The Commission has issued the enclosed Amendment No. 25 to License No. DPR-58; Amendment No. 25 to License No. DPR-47; and Amendment No. 22 to License No. DPR-55 for the Oconee Nuclear Station, Units Nos. 1, 2, and 3. The amendments consist of changes to the Technical Specifications and are in response to your requests dated May 7, 1976.

ATTACHMENT TO LICENSE AMENDMENTS

DOCKET NOS. 50-269, 50-270 AND 50-287

NOTICE OF ISSUANCE OF AMENDMENTS TO FACILITY
OPERATING LICENSES

OCONEE NUCLEAR STATION
STATION ORGANIZATION CHART
FIGURE 6.1-1

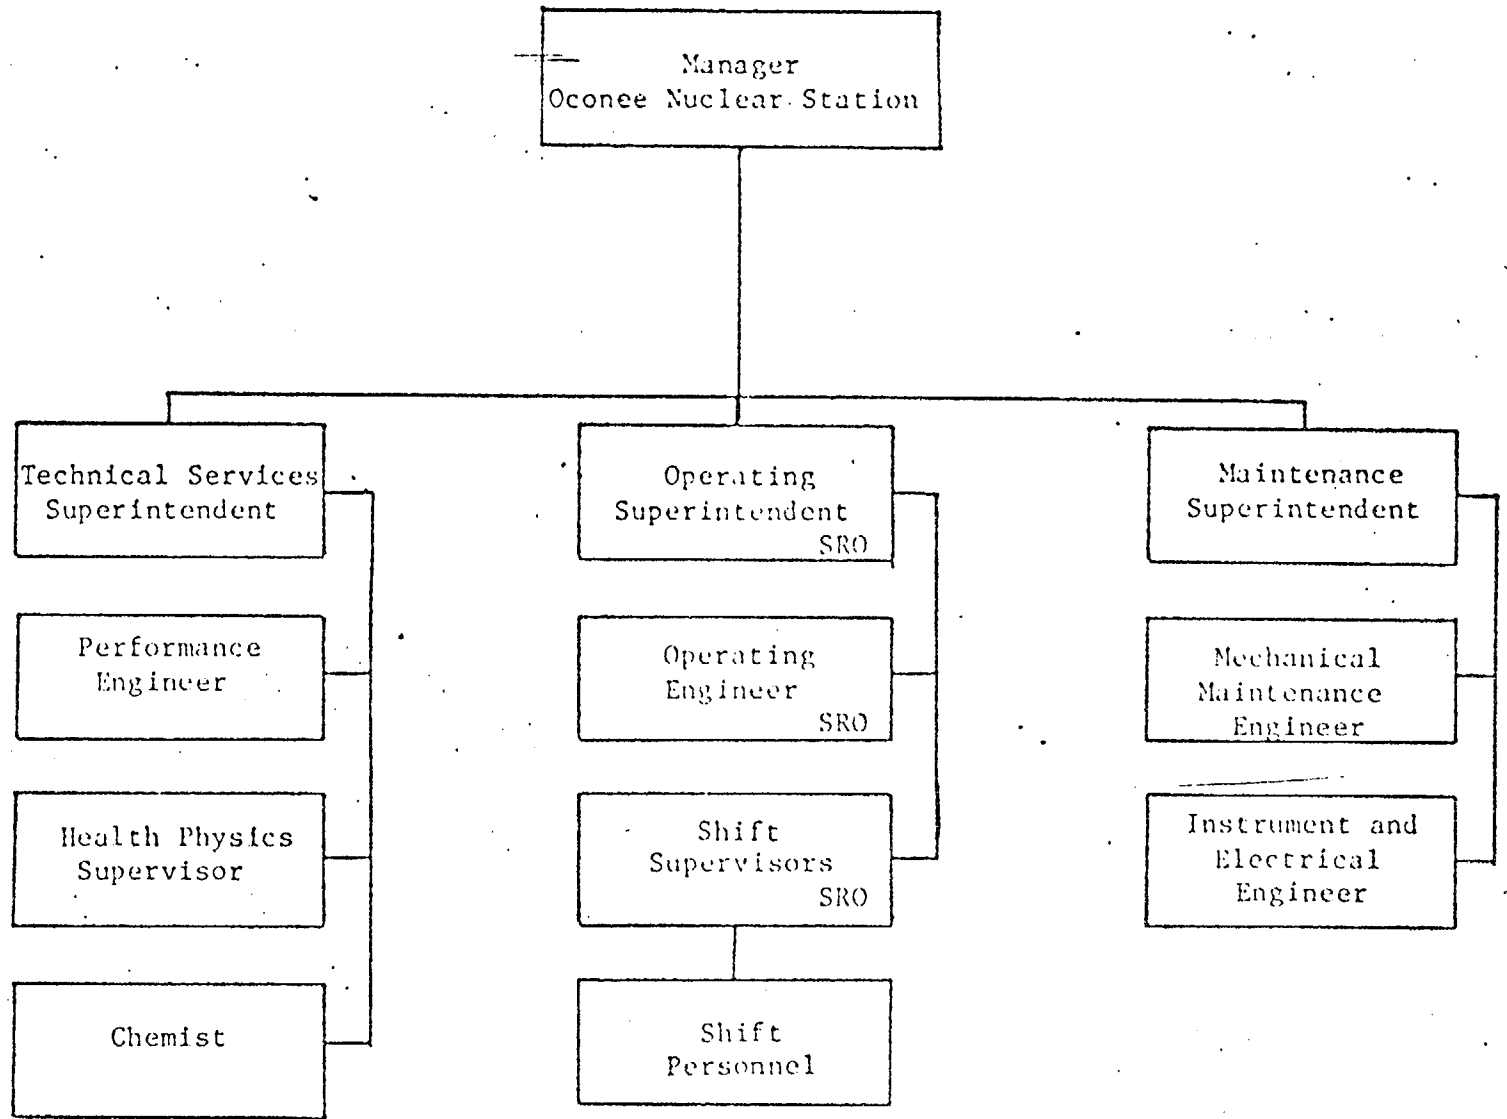
These amendments restructure the Oconee Station Organization for Maintenance by establishing two separate branches for mechanical and electrically-related maintenance. These amendments also revise the provisions in the Technical Specifications to require annual reporting of the nonradiological environmental data.

Remove Figure 6.1-1 (page 6.1-1) and insert revised Figure 6.1-1 (page 6.1-7)
